**Námořní navigační a radiokomunikační zařízení
a systémy – Integrované navigační systémy (INS) –
Část 2: Modulární struktura INS – Požadavky
na provoz a funkci, metody zkoušení
a požadované výsledky zkoušek**

**ČSN
EN 61924-2
OPRAVA 1**

IEC 61924-2
(First edition – 2012)

CORRIGENDUM 1

Clause K.2 ACM – Alert command

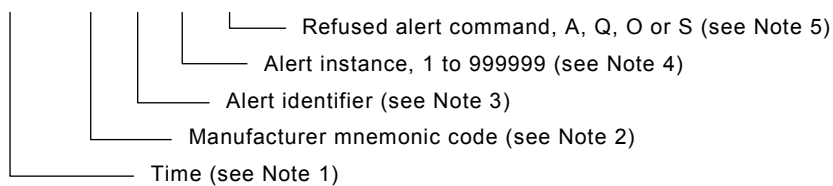
Replace, in the title and the sentence definition (fourth paragraph) ACM by ACN as follows:

K.2 ACN – Alert command

\$--ACN,hhmmss.ss, aaa, x.x, x.x, c, a*hh <CR><LF>

Figure J.1 – Legacy sensor communication showing priority reduction

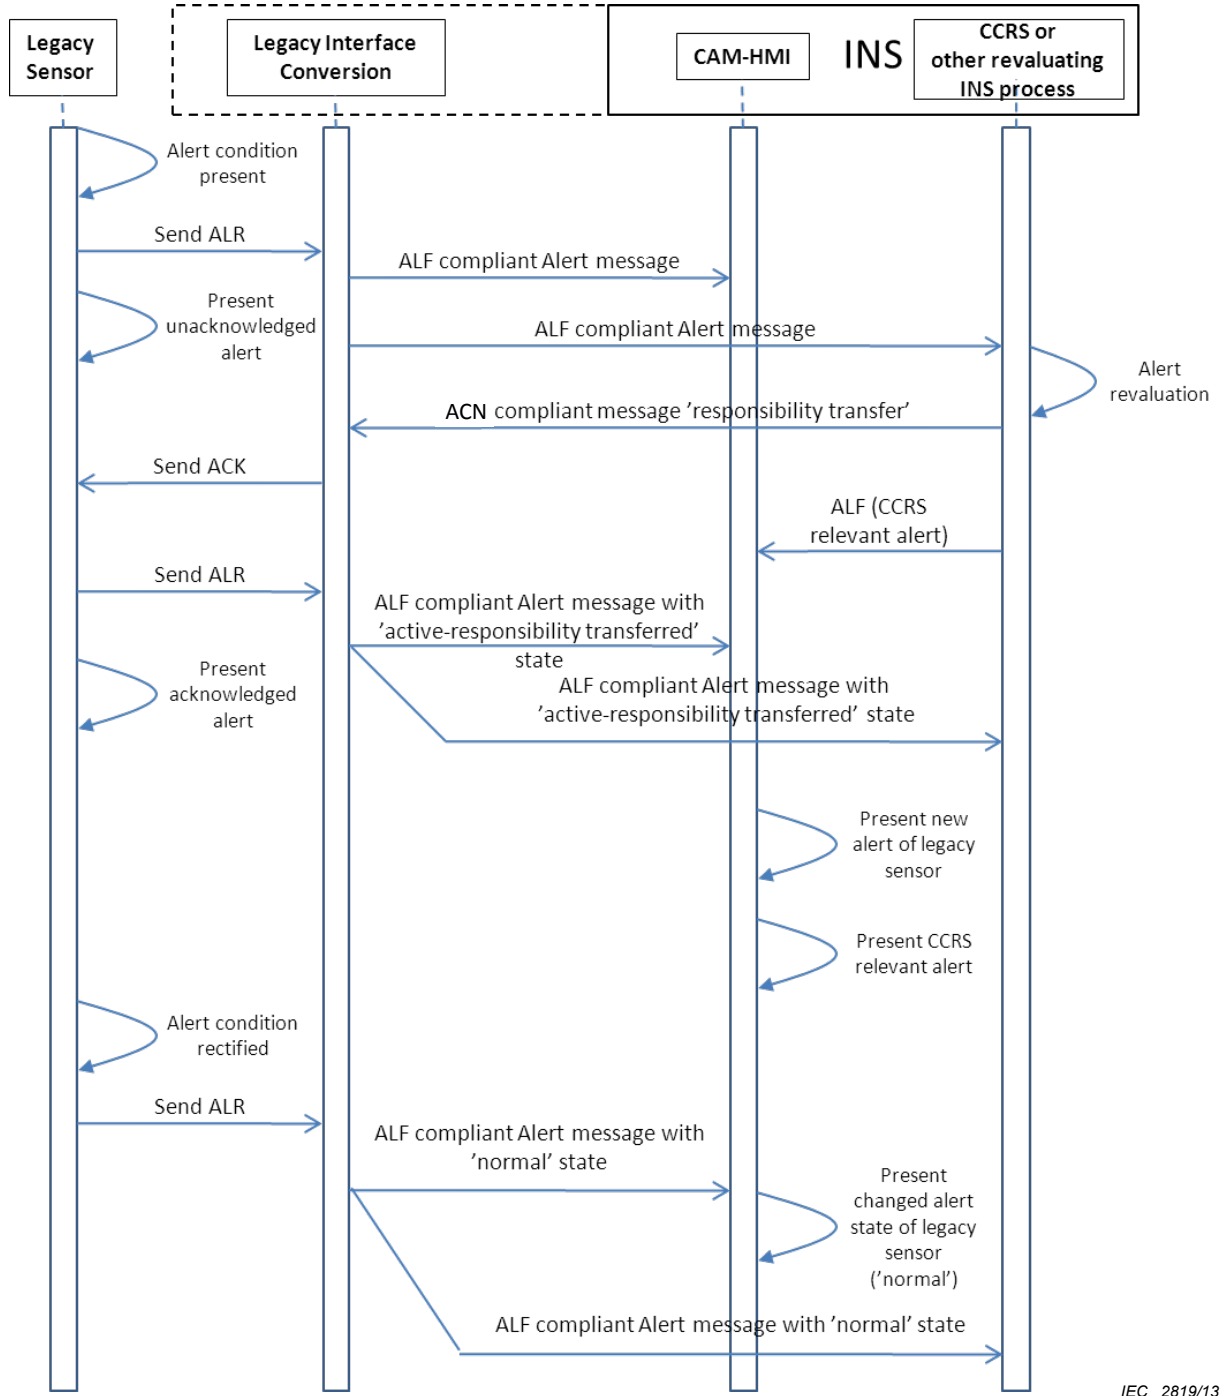
J.3.2	1 st paragraph	
Table J.1	6 th row	
Table J.1	7 th row	
Table J.2	Title	
Table J.2	1 st row, column title	
J.3.2	example below Table J.2	1 occurrence
Figure J.1		1 occurrence, see below
J.3.3	1 st paragraph, below Figure J.1	
J.3.4	1 st paragraph, below Figure J.2	
Clause J.4	Title	
J.4.1	1 st paragraph	2 occurrences
Figure J.3		1 occurrence, see below
Figure J.4		1 occurrence, see below
J.4.6	Title	
J.4.6.1	1 st paragraph	
J.4.6.2	1 st paragraph	
Figure J.5		8 occurrences, see below
Clause K.3	2 nd paragraph	
L.1.1	1 st paragraph
